RE: 3M Cordova RCRA Facility Assessment

ILD 054 236 443

SUBJECT: RCRA Facility Assessment 3M, Cordova, Illinois

Visual Site Inspection of 3M Co., Cordova, Illinois

(Original source: Figure 2 of the "Sludge Incorporation-3M Cordova" report submitted to U.S. EPA on August 29, 1986 in response to a request-for-information letter re. corrective action requirements)

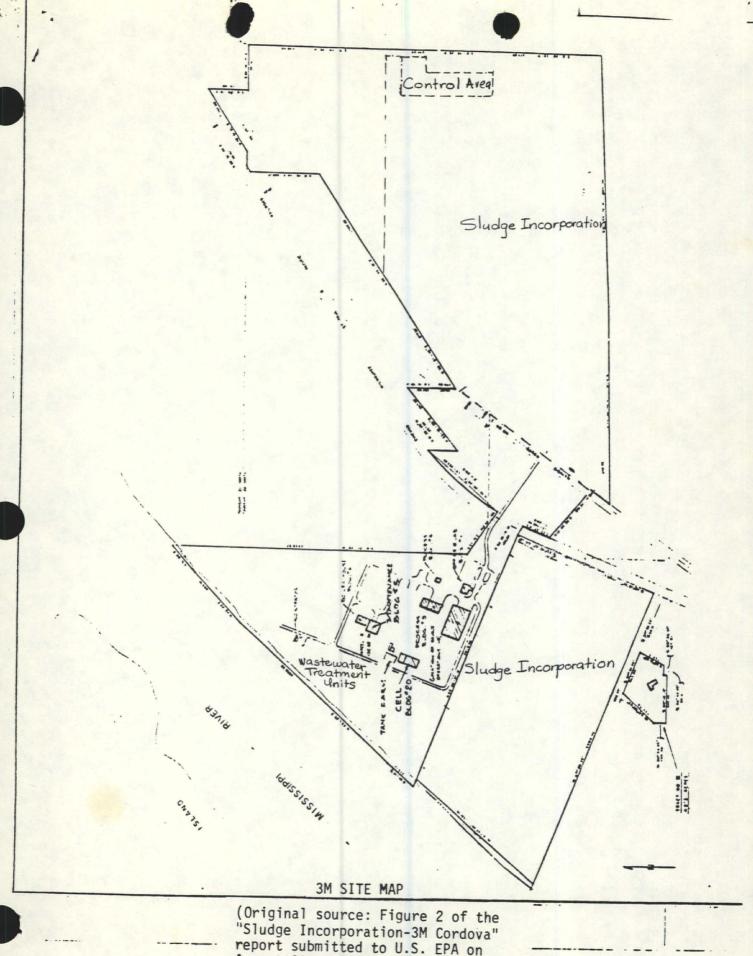
The sludge incorporation area encompasses some 371 acres of 3M-owned farmland adjacent to the plant site. 3M has been authorized by the Illinois EPA to apply over 3 million gallons of "aerobic digester sludge" into the soil. This activity began in 1975. The sludge is incorporated by 3M personnel. 3M pays a local farmer for farming the land during the summer. All harvested crops (corn) are owned by 3M.

In conclusion, the sludge incorporation areas appear to have a potential for the release of hazardous constituents to the soil and groundwater. 3M's 1982 report on its sludge incorporation program has not provided enough information to conclude that no contamination of the subsoil beneath the sludge incorporation areas and of the groundwater has occurred as a result of this activity.

The RFI required in the U.S. EPA portion of the RCRA permit for 3M will specify that the sludge incorporation areas be investigated. The RFI will require that 3M prepare a detailed sampling plan capable of determining if releases to the subsoil and/or groundwater have occurred.

FIGURE 1

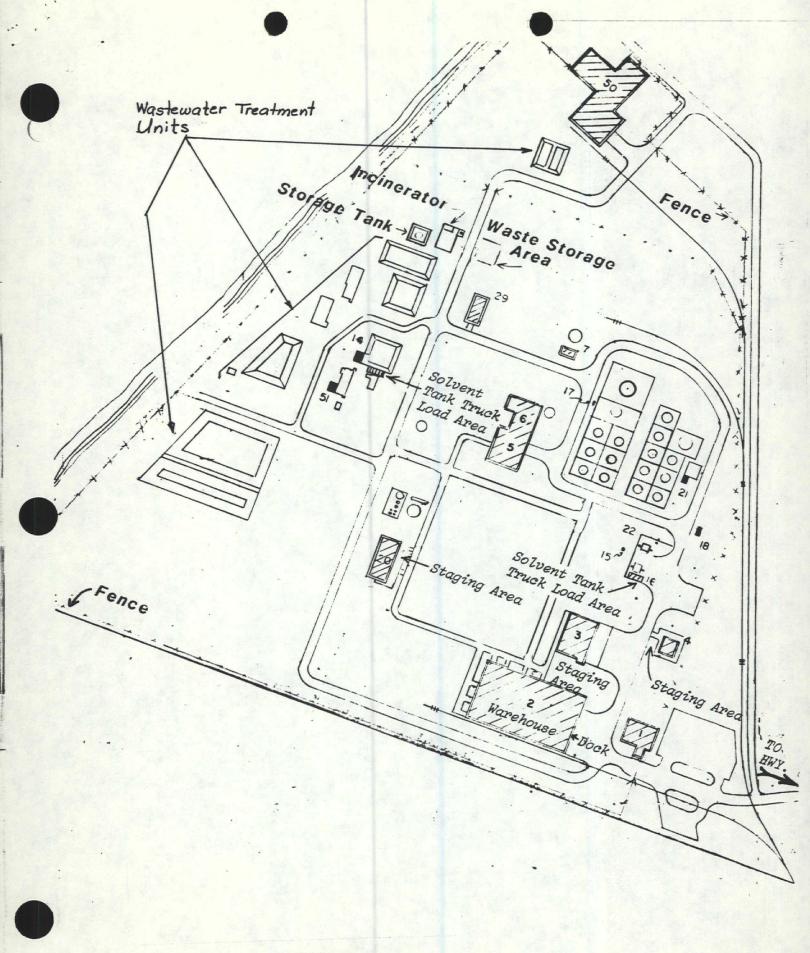
The following is a summary of the information gathered during the site inspection. Please refer to Figures 1, 2, and 3, which show the areas inspected. The land farm areas were not included in those figures, because 3M has not yet identified their exact location.
